July 23, 1992

RE: St. Johns Landfill Cover Vegetation Plan - Sub-Area 1 Test Plot Plan

**SUBAREA 1 TEST PLOT PLAN**

**ST. JOHNS LANDFILL COVER VEGETATION PLAN**

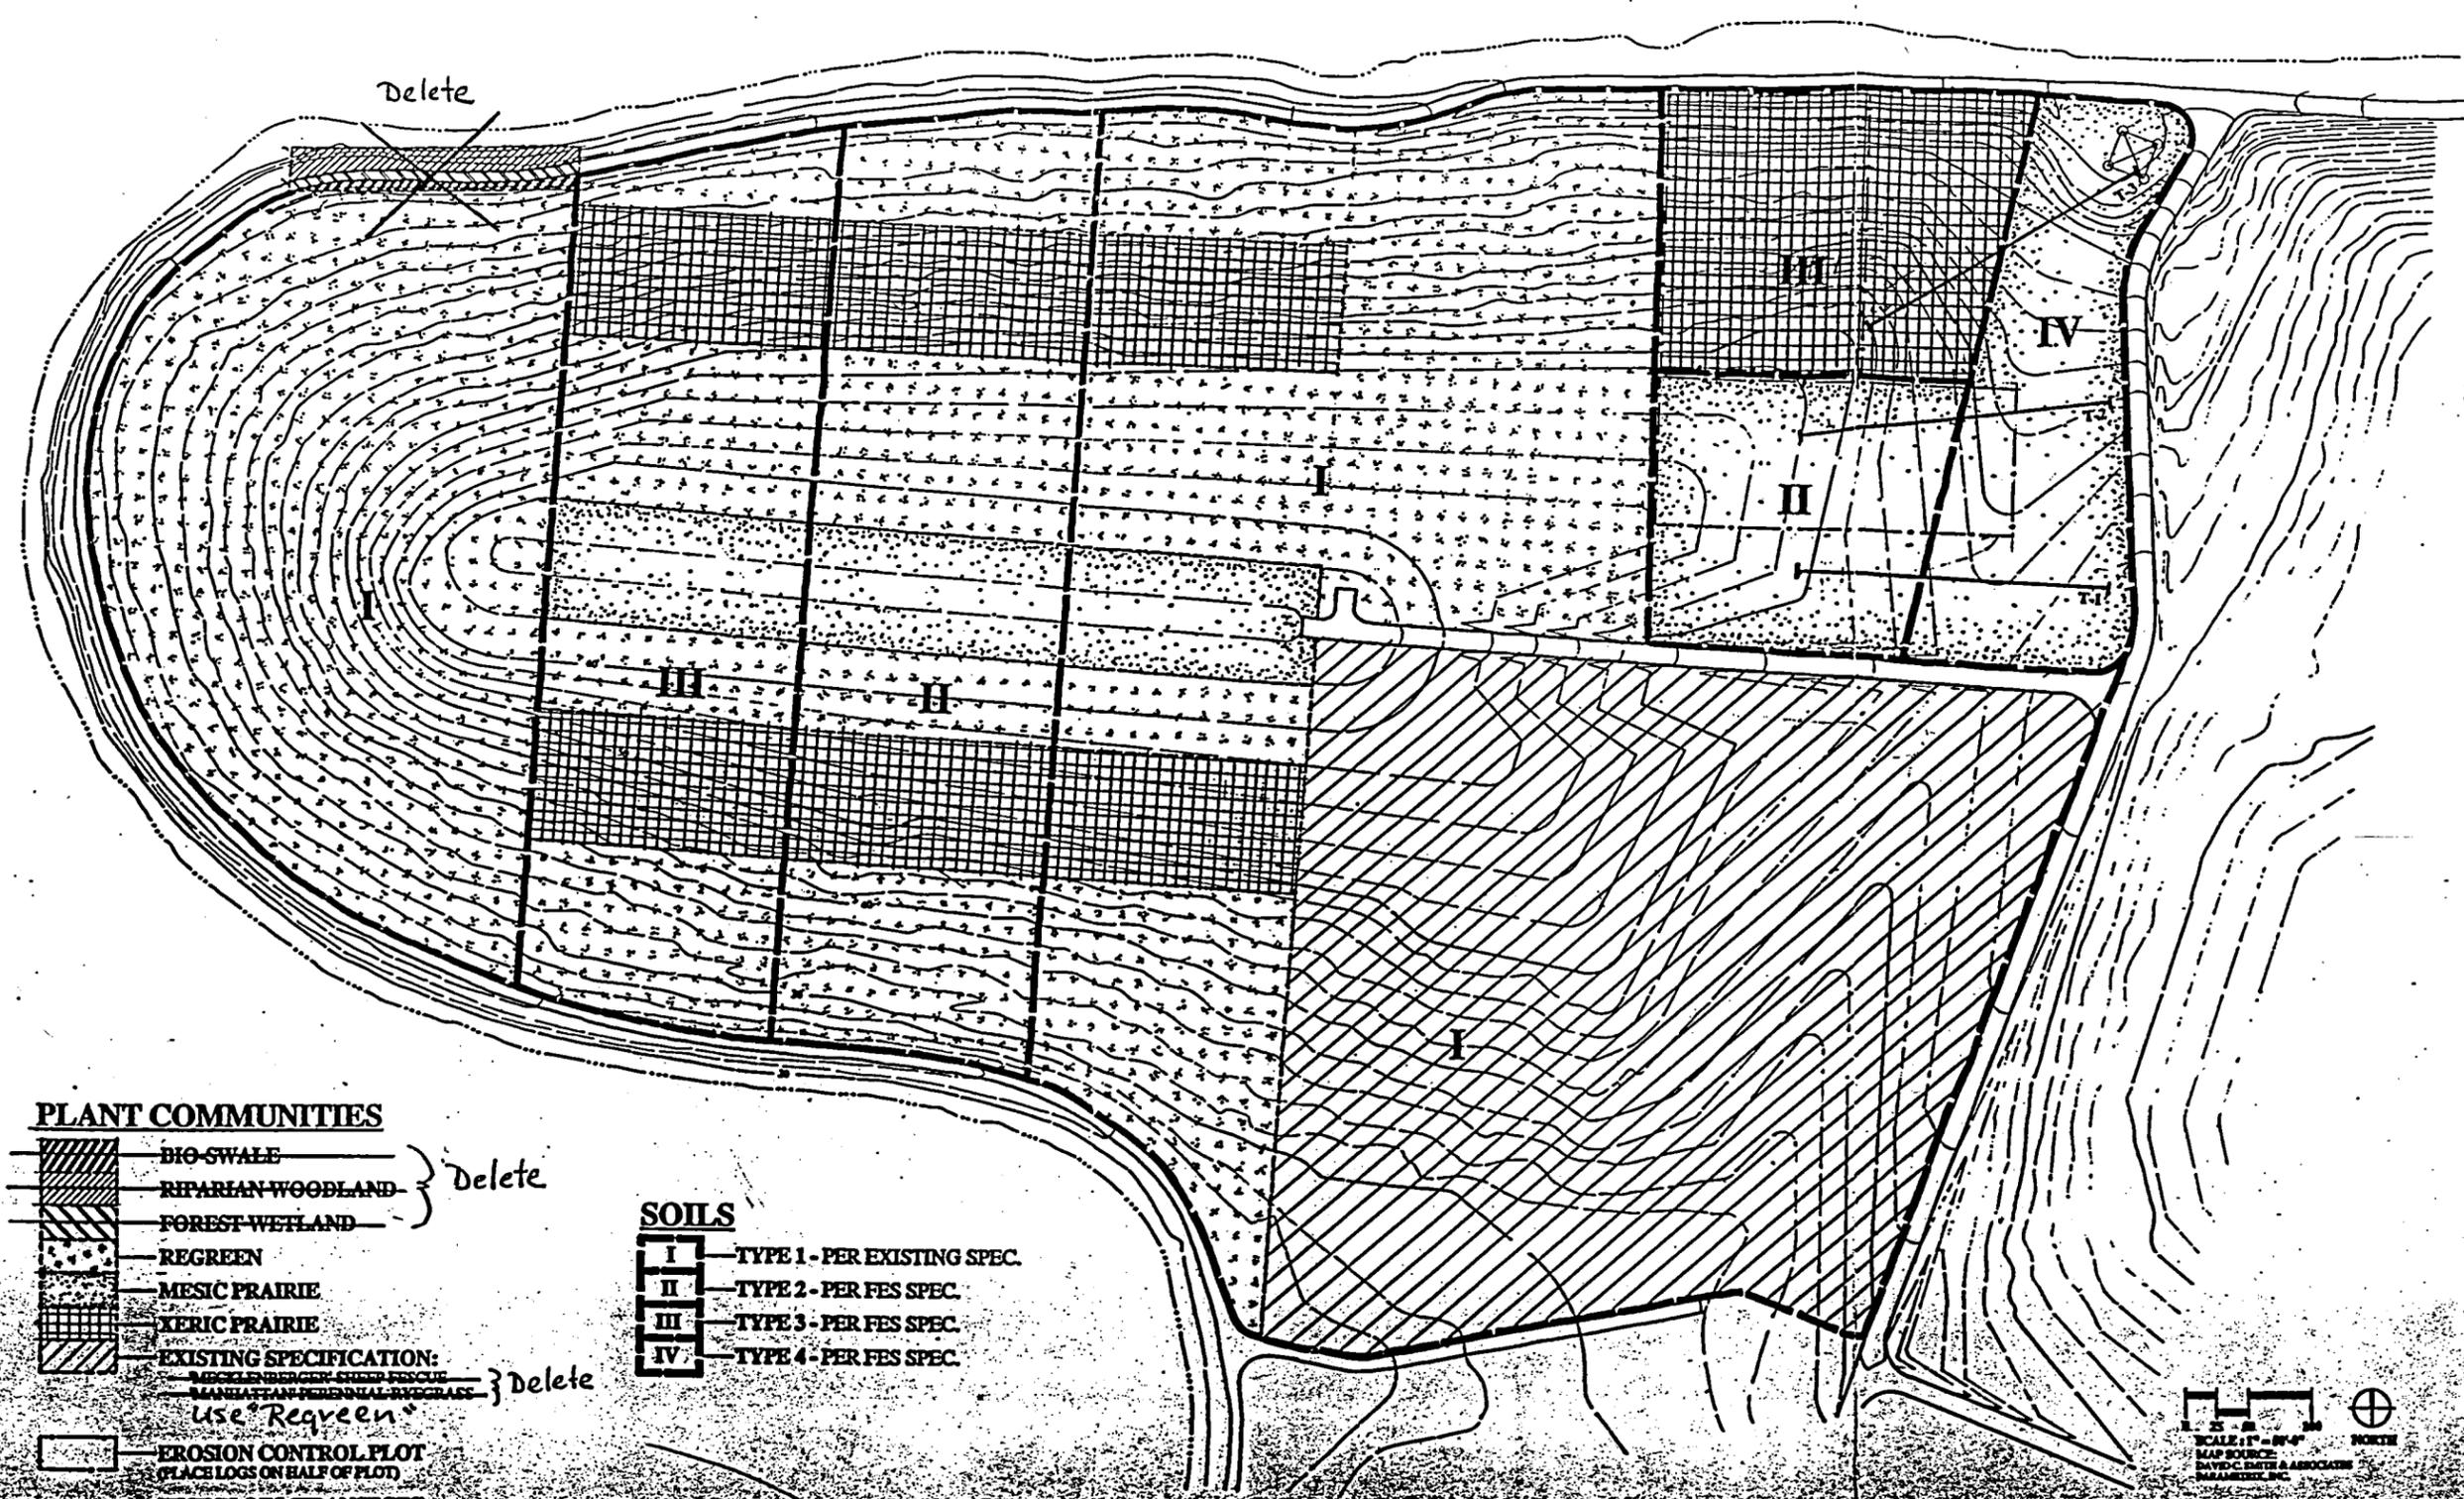
The purpose of this letter is to serve as an advance warning of expected direction to execute changes in soil profiles and vegetative cover in Sub-Area 1. It is our intention to use the cover for Sub-Area 1 to study the mutual effects of soil, plant types, slope and orientation in order to arrive at the best design for the entire landfill. Fishman Environmental Services has produced a "Draft Report" which is included with this letter. The "Draft Report" is not a construction document and elements of the proposed test have already been changed to facilitate construction. We do not plan to construct the bioswale/forest wetland/riparian woodland at this time.

Attached as Enclosure 1 is an outline of the test areas currently planned for Sub-Area 1. Enclosure 2 is a table of the currently planned soil profiles. You will note that existing specifications for hydroseed mix and for imported topsoil no longer apply. No Mecklinberger Sheep Fescue or Manhattan Perennial Ryegrass will be planted. Topsoil will not be mixed offsite. Imported subsoil and imported compost will be placed and mixed in place in the test areas, and in other areas to supplement existing topsoil as required.

- BIO-SWALE
- RIPARIAN WOODLAND } Delete
- FOREST WETLAND } Delete
- REGREEN
- MESIC PRAIRIE
- XERIC PRAIRIE
- EXISTING SPECIFICATION:
  - MISCELLANEOUS - SHEEP FESCUE
  - MANHATTAN PERENNIAL RYEGRASS
 } Delete  
 Use "Regreen"
- EROSION CONTROL PLOT  
(PLACE LOGS ON HALF OF PLOT)
- TEST PLOTS (TRANSECTS)
  - T-1 - ROSA NUTKANA, SYMPHORICARPOS ALBUS
  - T-2 - AMELANCHIER ALNIFOLIA, SALIX SCOULERIANA
  - T-3 - AMELANCHIER ALNIFOLIA, SALIX SCOULERIANA
